**Stakeholder Meeting #4 Minutes: Friday, August 21st, 2015**  
**State Route 37 Integrated Traffic, Infrastructure and Sea Level Rise Analysis**  
**Marin Humane Society, 171 Bel Marin Keys Blvd.**  
**Novato, California 94949**  
**10:00am – 12:00pm**

# SR 37 Sea Level Rise Adaptation Engineering Concept Design & Cost Estimates

# Sea Level Rise Design Criteria Alternative 1 (Levee)

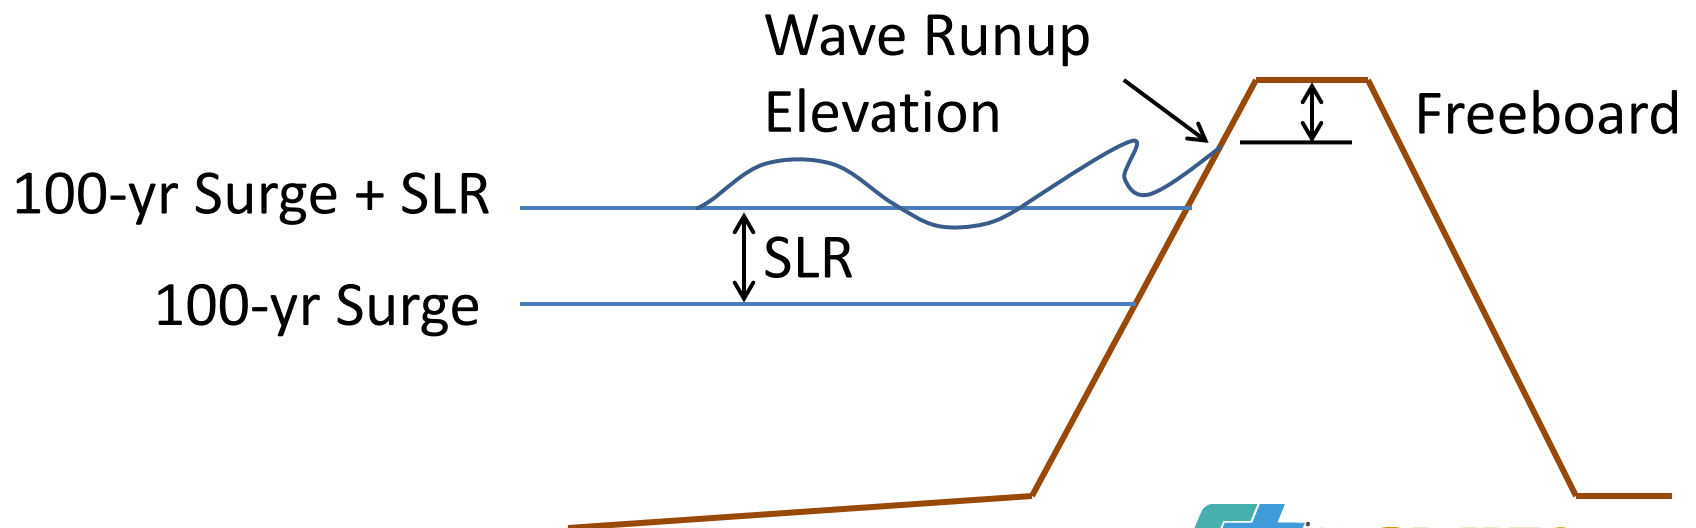
### Sea Level Design Criteria Alternative 1 (Levee) **(Slide 21)**

- The sheltered Reaches are areas protected by levees
- The exposed Reaches are not protected by levees
- Freeboard is the difference between the water level and the roadway.

Question: Why is the SLR only 3ft?

Answer: The SLR scenario that was selected was end of century mid-range estimate. This is at a conceptual level but can certainly be higher. The typical high range estimate at the end of the century is about 66". There is a little bit of freeboard built into that but a higher scenario could be used and be refined as we move farther into stages of the design.

# Alternative 1: Footprint Reach A

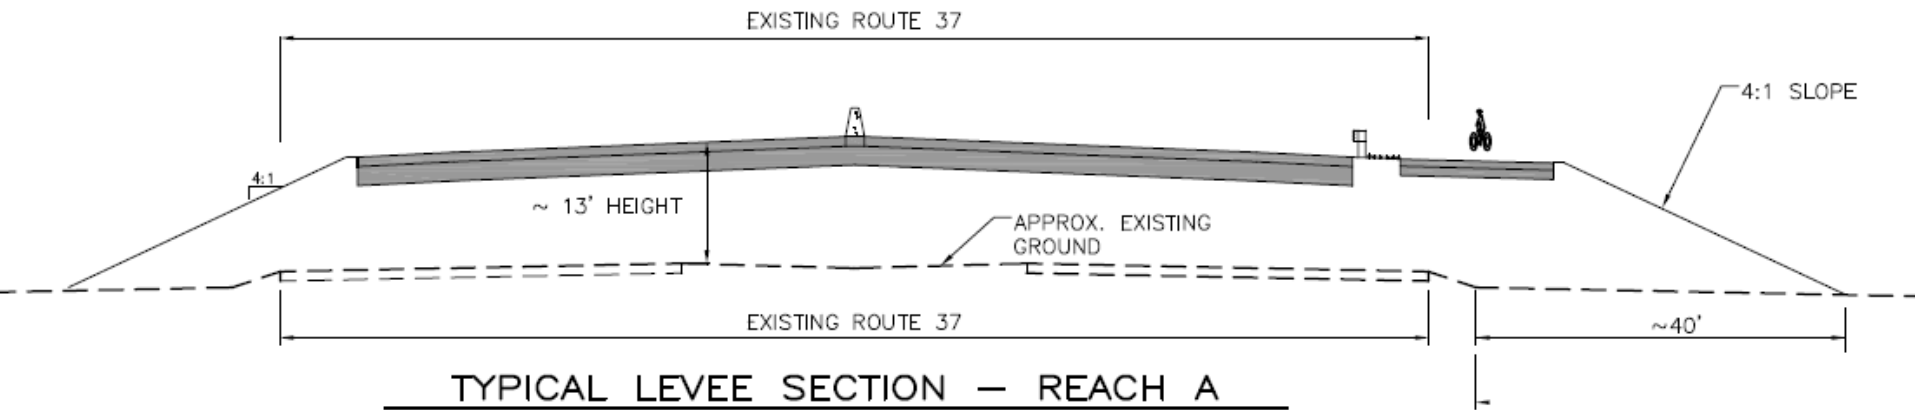
Question: What is the dimension of fill on Alternative 1: Footprint Reach A?

Question: Is this in Caltrans ROW?

Question: Have you looked at the width and potential need for drainage?

Answer: Between 30' and 40'

Answer: That is still to be determined because we don't have the exact alignment.

Answer: Not in great detail but we did allow for drainage when we did the cost estimate.

# Alternative 1: Living Levee Concept

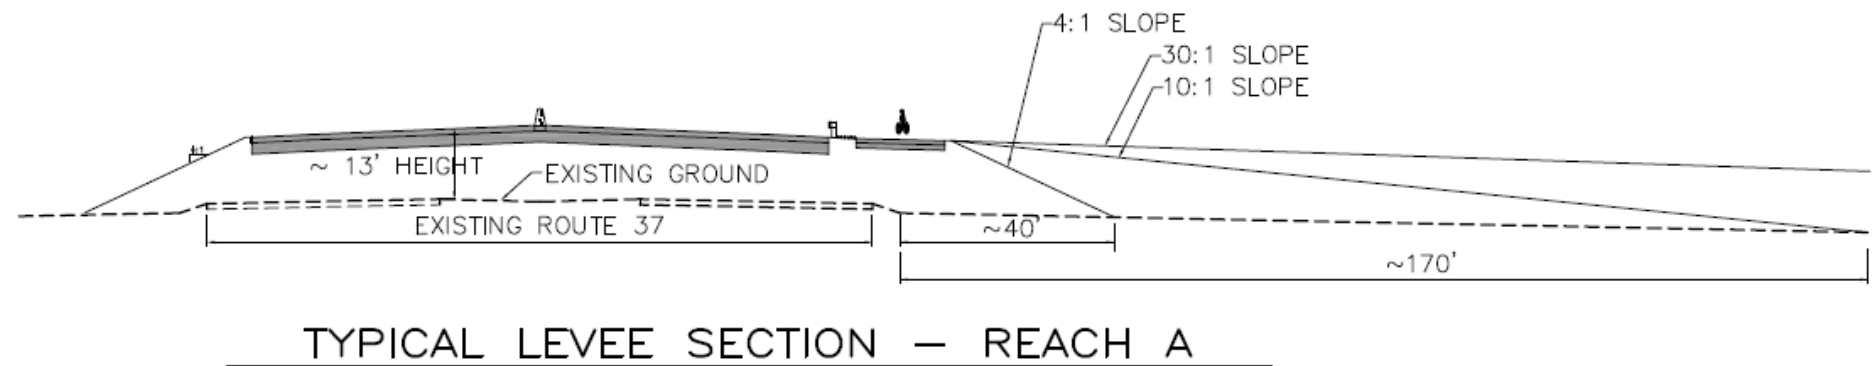
Question: Reach A – currently levee protected. Would some of the assumption be that you would have something that dissipates wave action in a protected area because at some point it might not be protected? On either side of Black Point there is currently levee protection. Reach A is easier to picture because there is less wetland and it would sit on top of it. Reach B would have a living levee sitting on a previously living marsh – harder to picture. If you had this in Reach A, then what is the advantage? Is it because it might become unprotected?

Question: How is the railroad track affected?

Question: Does the RR act as levee in some portions?

Answer: Yes.

Answer: It has to be raised or moved to the south, depending on where the alignment would be. They run from SR 121 to almost Atherton Ave. so it would be about 3.5 miles. There is an existing levee system on Reach A that protects it but not from SLR. Current 100yr storm surge + SLR would overtop it.

Answer: Yes. The railroad runs parallel to Hwy 101 to Atherton Ave.

# Alternative 1: Roadway on Levee Conceptual Cost Estimate

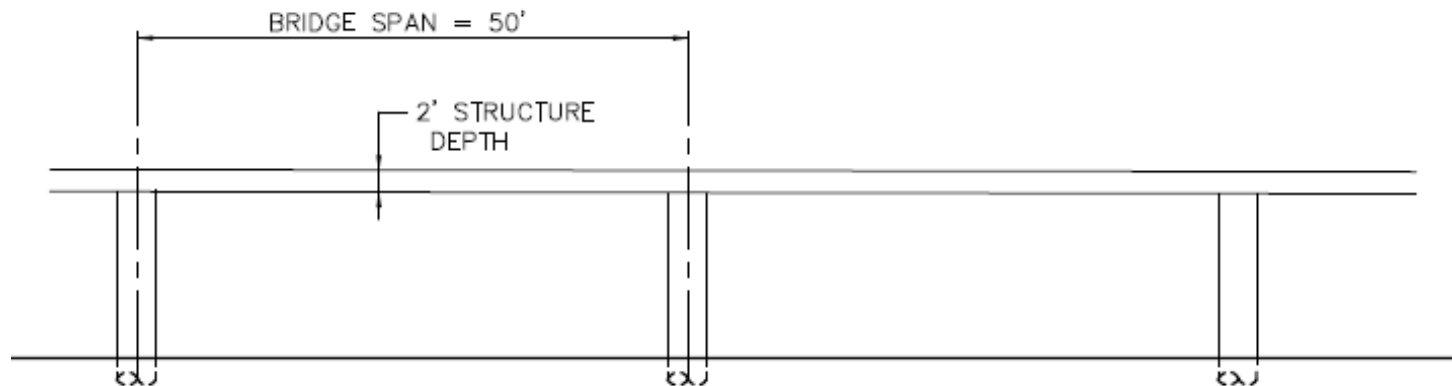
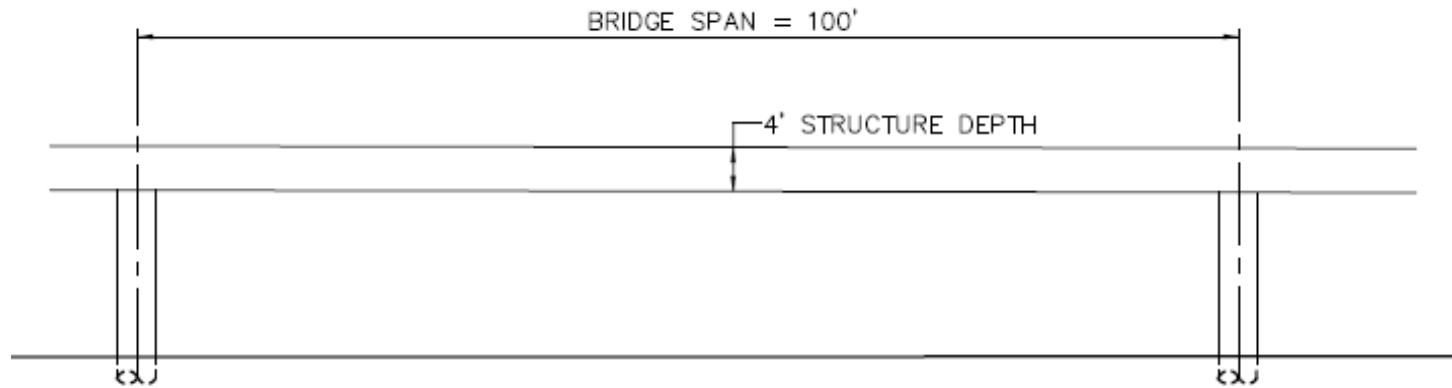
Question: Is the environmental mitigation cost rolled into the support cost?

Question: Estimate includes replacing existing bridges but does it include any considerations for new overpass interchanges, especially at SR 121?

Questions: Is the cost of \$300M - \$470M inclusive of /contingency and the soft cost?

Question: Is this a CPI inflator? No, it's not. It's an uncertainty inflator. This is if you built it now, right?

Answer: Yes

Answer: Yes

Answer: Yes. The two estimates, order of magnitude include the soft costs. The basis for contingency is that it's likely that future costs will go up - we don't know when it would be built so its current estimate is that it will appreciate over time. Because there is such limited information in mapping; it is very dynamic and costs change with the detail of design. The contingency actually increases with changes.

Answer: Yes. They go up. This is if we build it now. We should keep track of inflation cost over time and uncertainty associated with the process. We should keep them separate so we say which is which.

# Alternative 2: Footprint Reach A

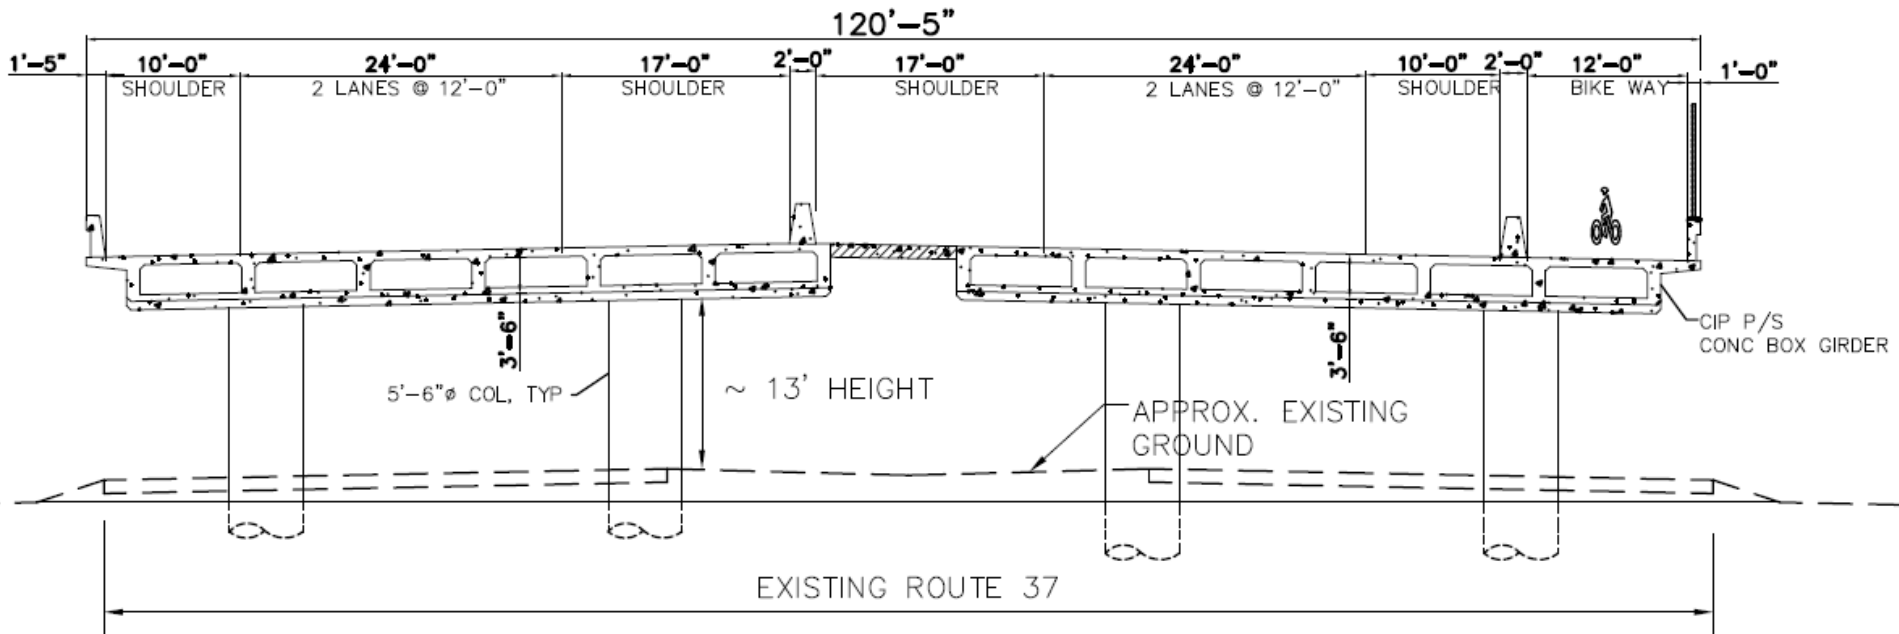
- It costs a little more than the levee
- About 121' wide
- Provides the same features as the levee section other than the separation between the bikeway and the shoulder roadway is reduced.

# Alternative 2: Footprint Reach B

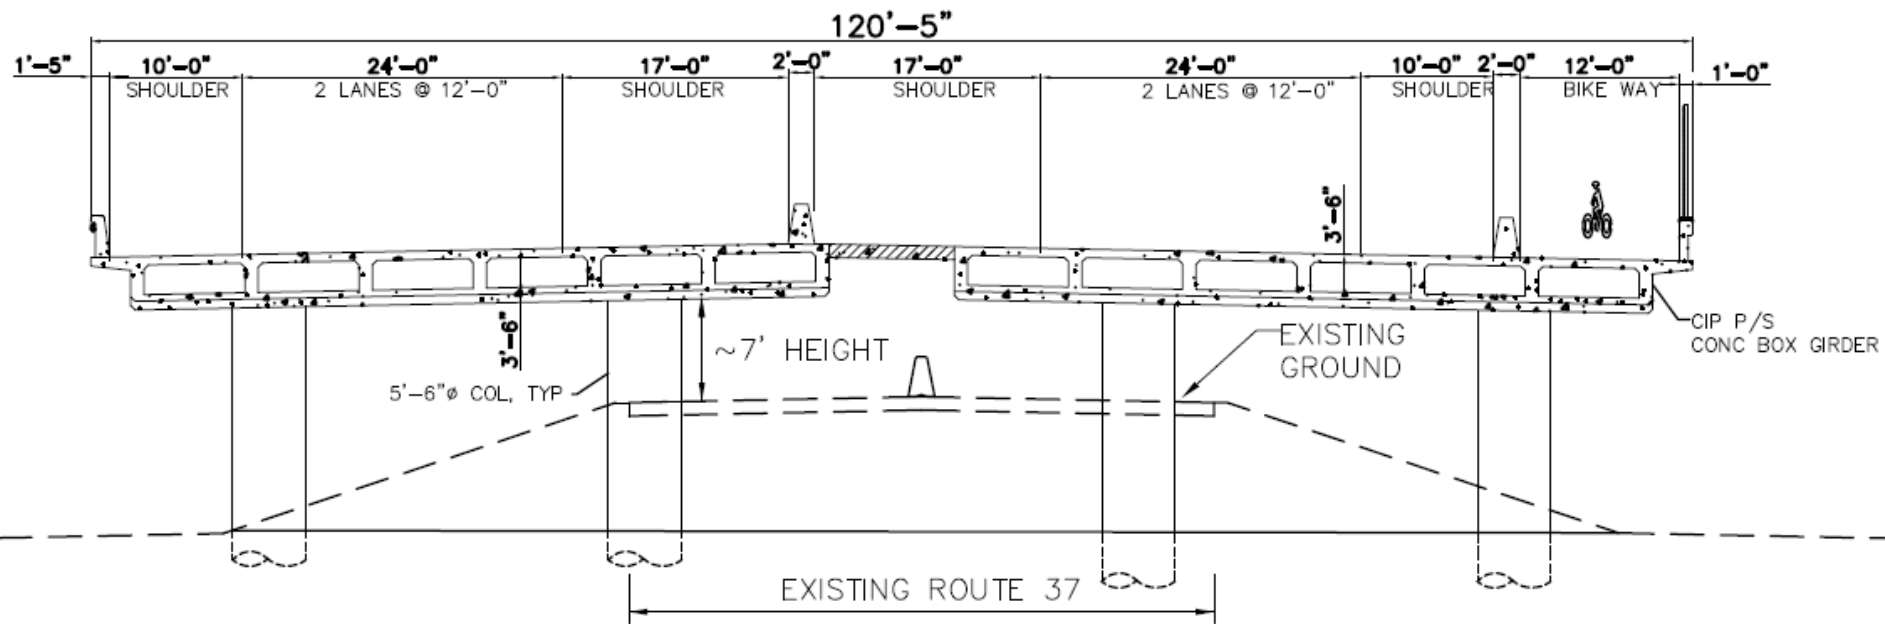
- For medium to long spans of 50' column to column, up to 120' to 150'
- Usually used when you have a clearance of at least 15', this type of structure is used.

Question: Because we don't know a lot about the depth to bedrock, how much does that change the cost? How much is the cost related to pier depth?

Question: Caltrans currently has requirements for how storm water is managed off facilities and since there is a marsh under there, do you think those new requirements for storm water management would place a large additional cost on a structure like this to clean it up before it hits the ground?

Answer: The deck costs more but the pier is 10% to 20% more if the pier depth is doubled.

Answer: Will have to look into that, don't really know the costs.
